September 29, 2023

RE: Requesting Meeting to Receive Update regarding the City of Rollingwood's Official Public Comment dated January 7, 2022

Exhibit A - City of Rollingwood Official Comments dated January 7, 2022

RE: Official Public Comment on the MoPac South Environmental Study Virtual Public Meeting Number Five

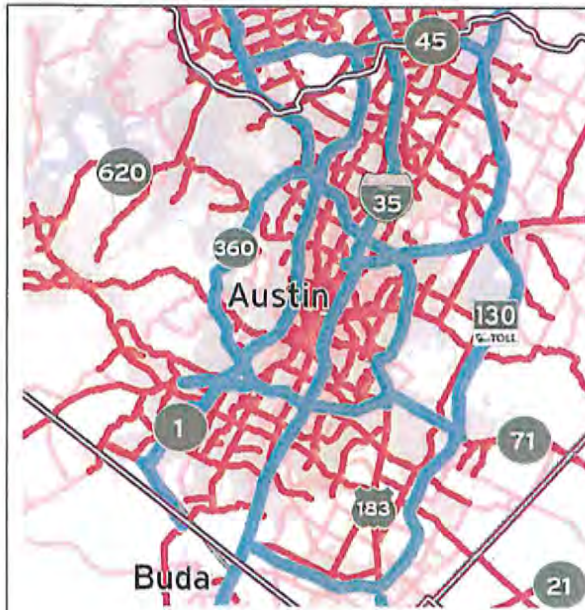
(c) Bee Caves Road is shown as a “principal arterial” from east to west, however, the Regional Corridor Inventory describes 9 segments of Bee Caves Road.

(d) It is unclear whether the Regional Corridor Inventory previously provided to the City of Rollingwood was informed by the “existing” map on page 7 of the “Arterial Boards” or whether the Regional Corridor Inventory has been updated to reflect the “existing” map.

(2) As to the “planned” map on page 7 of the “Arterials Boards”, based on the “2040 Planned Network:

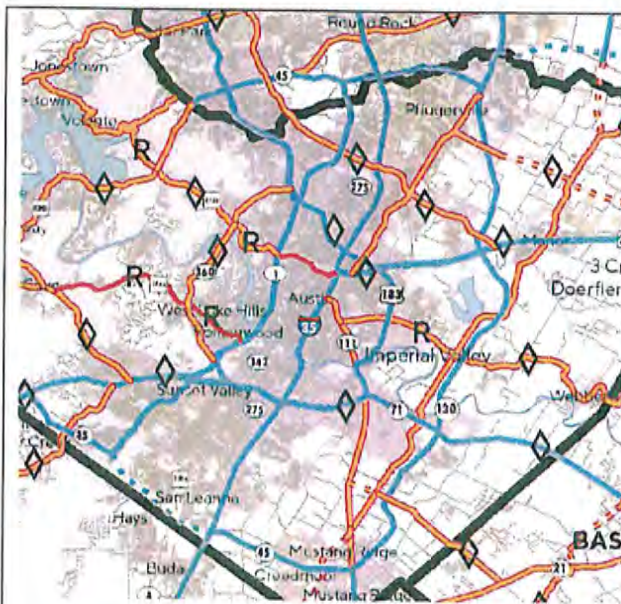
(a) Loop 1 is classified, from 45N to the 45SW, as a “limited access” segment. The Regional Corridor Inventory previously provided to the City of Rollingwood does not provide any description of any planned improvements to Loop 1 to support the “planned” map.

(b) Based on project descriptions in the CAMPO 2040 plan, the “planned” map appears to show primarily “managed lane” planned roadways as the “limited access” roadways.

(c) The CAMPO 2040 Plan specifically segments planned updates to Loop 1 South between the limits of Cesar Chavez and Slaughter Lane, but provides no planned improvements between Slaughter Lane and 45SW.

(d) It is unclear whether the Regional Corridor Inventory previously provided to the City of Rollingwood was informed by the “planned” map on page 7 of the “Arterial Boards” the CAMPO 2040 plan, or whether the Regional Corridor Inventory has been updated to reflect the “planned” map or CAMPO 2040 plan.

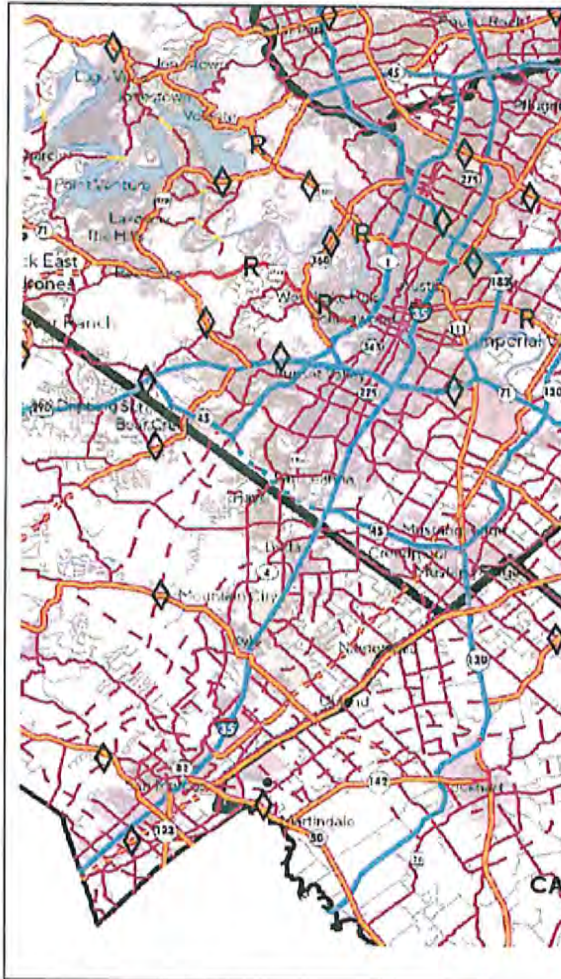
(a) In “Scenario A”, “Scenario B”, and “Scenario C”, Bee Caves Road is proposed as including a “reversible lane” scenario. P. 5 of the “Arterial Boards” shows the only potential design option for a reversible lane by repurposing a center turn lane as a reversible lane. It is unclear from the Regional Corridor Inventory that the “improvement” listed under regional project number 90.1 of Bee Caves Road as an undivided 4 lane road, would contemplate using the almost completed safety improvement of a center turn lane between Loop 360 and Rollingwood Drive, as a reversible lane, instead of a center turn lane.

(b) In “Scenario A”, “Scenario B”, and “Scenario C”, it is unclear why a dotted line is proposed between the southern point of Loop 1 and I-35 as a “limited access” roadway, but the existing improvements, of both SH45SW, which is shown on both the “existing” and the “planned” maps, and the upgrade of FM 1626 from a “minor arterial” in the existing map to a “principal arterial” in the “planned” map, are not considered. The City of Rollingwood has commented in the past requesting that the traffic impacts on Mopac South due to the constructions of SH45SW and the upgrade to FM1626 have not yet been adequately measured; the City of Rollingwood is opposed to converting Loop 1 into an I-35 bypass, to the detriment of local traffic, which would be effected if Loop 1 is designed with express lanes directly connected to I-35 South of downtown Austin to I-35 North of downtown Austin.
